GENERAL NOTES
INTERIOR T-BAR CEILING FRAMING

PROJECT: PORTLAND EMERGENCY COORDINATION CENTER
PROJECT LOCATION: PORTLAND, OR.
CLIENT: WESTERN PARTITIONS, INC.

JOB NO.	12-662
DRAWN BY:	DEVCO
SHEET TITLE:	GENERAL NOTES
DRAWING:	SK 0

JOB NO. 12-662
DRAWN BY: DEVCO
SHEET TITLE: CONNECTION DETAILS
DRAWING: SK 1

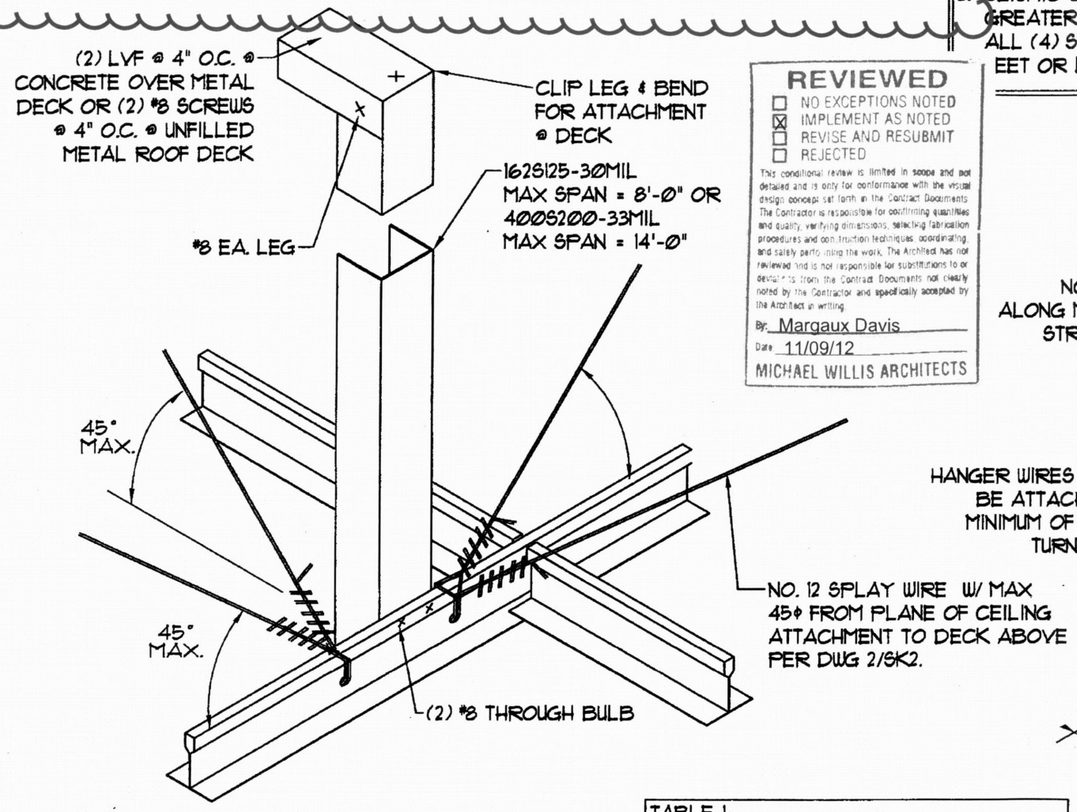
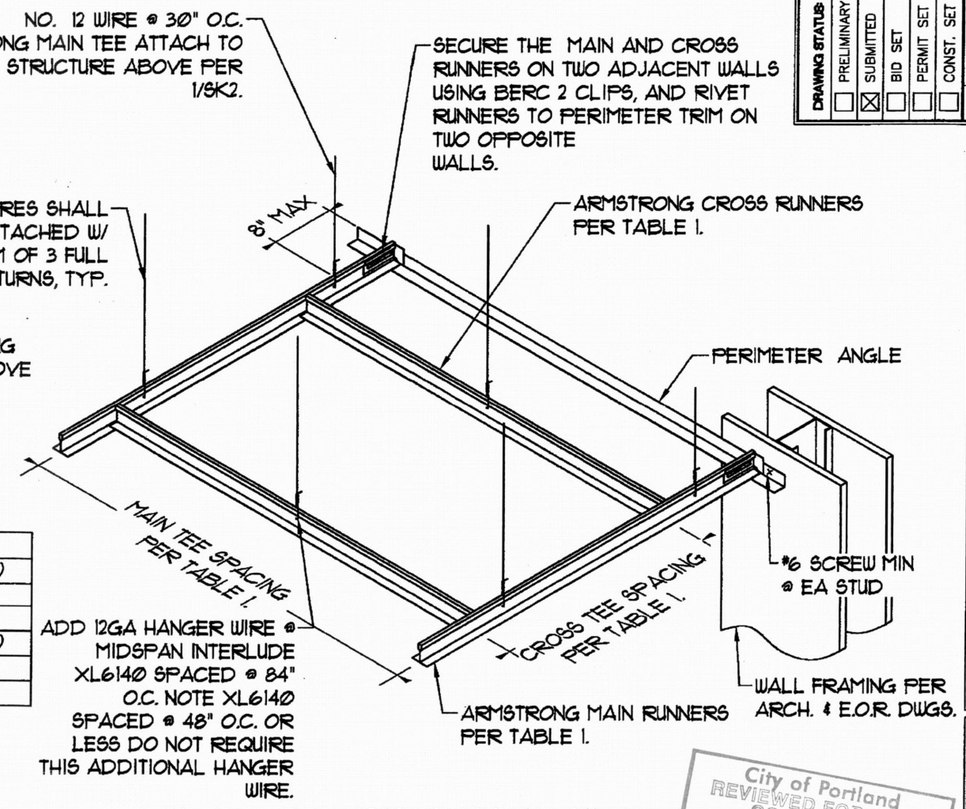
Install w/ approved fasteners and locations per approved structural calcs.
Install per manufacturer's requirements for Seismic Category 'D'
(attached as part of submittal)
See Detail 9/A0.04 for additional info.

JOB NO. 12-662
DRAWN BY: DEVCO
SHEET TITLE: CONNECTION DETAILS
DRAWING: SK 2

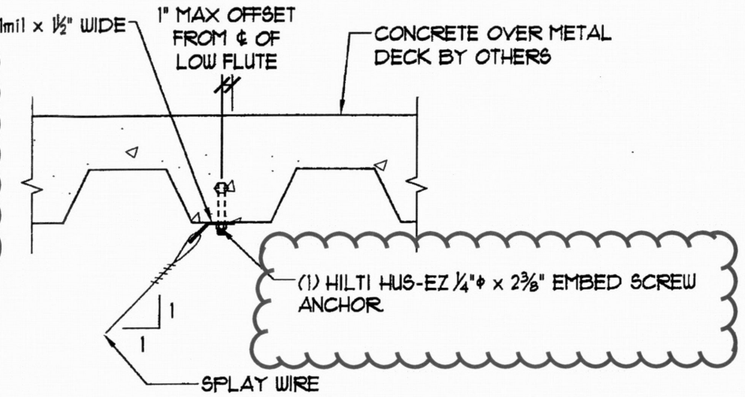
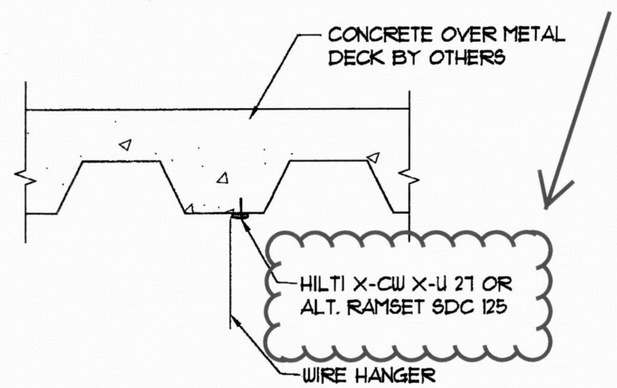
Install w/ approved fasteners and locations per approved structural calcs.
Install per manufacturer's requirements for Seismic Category 'D'
(attached as part of submittal)
See Detail 9/A0.04 for additional info.

Per approved fastener and methods described on approved structural calcs (ABHT 11/09/2012)

DRAWING: SK 3

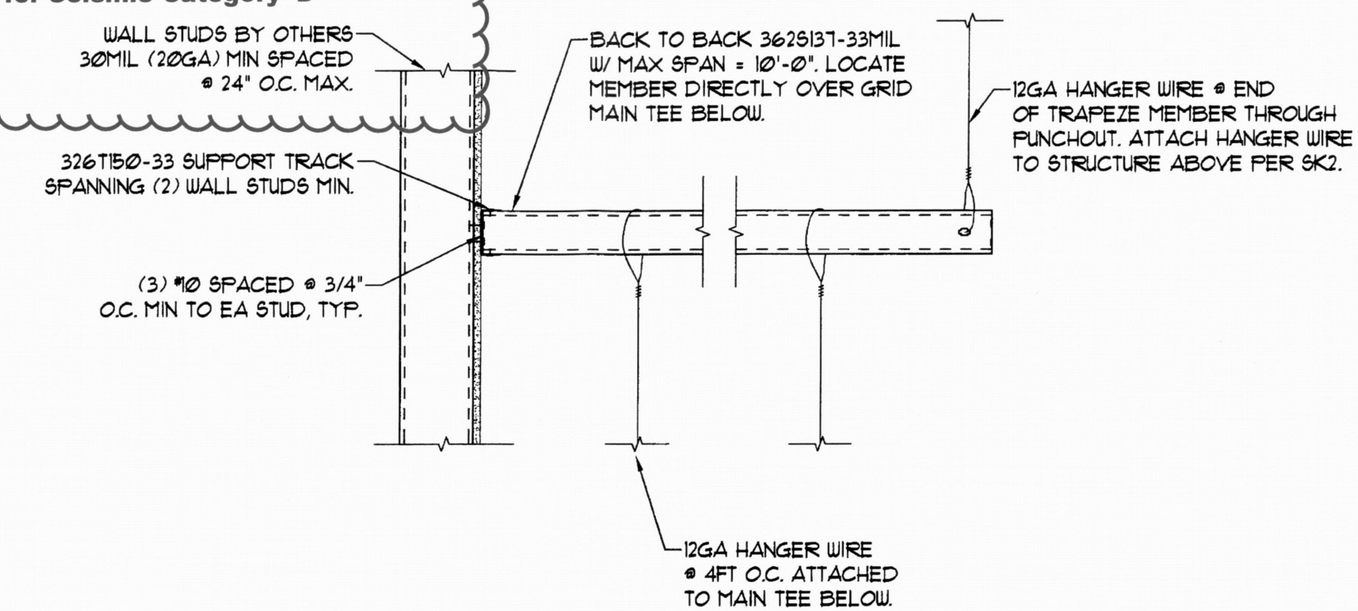
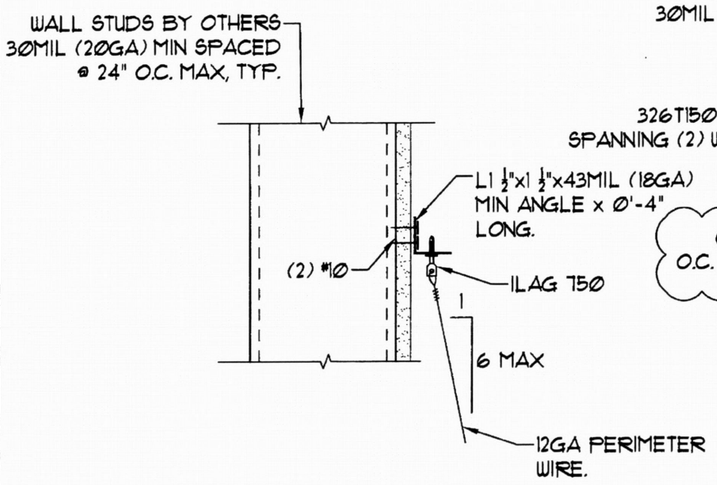
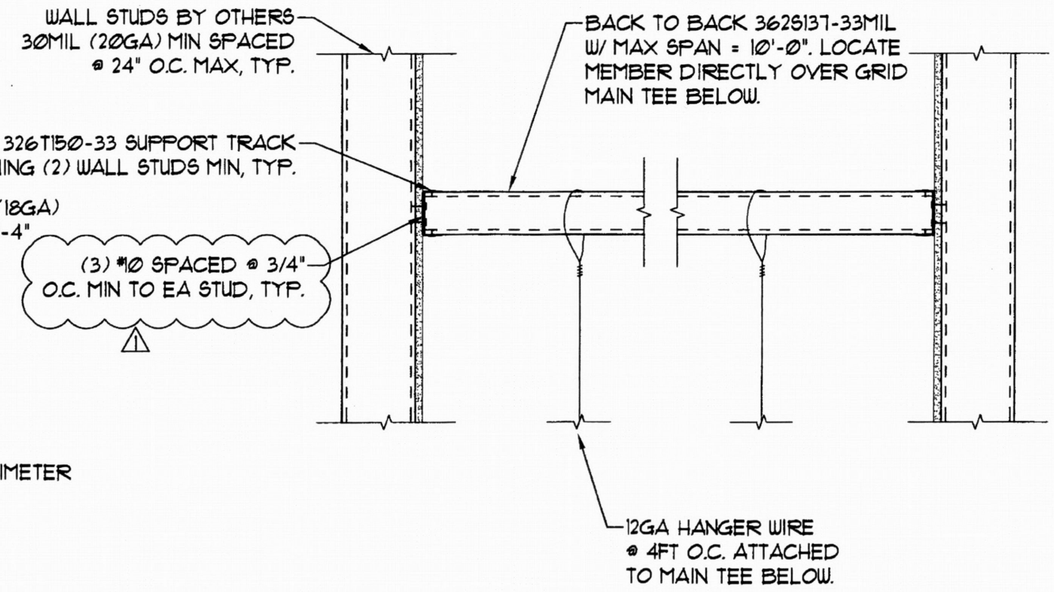
Install w/ approved fasteners and locations per approved structural calcs.

Install per manufacturer's requirements for Seismic Category 'D' (attached as part of submittal)

See Detail 9/A0.04 for additional info.
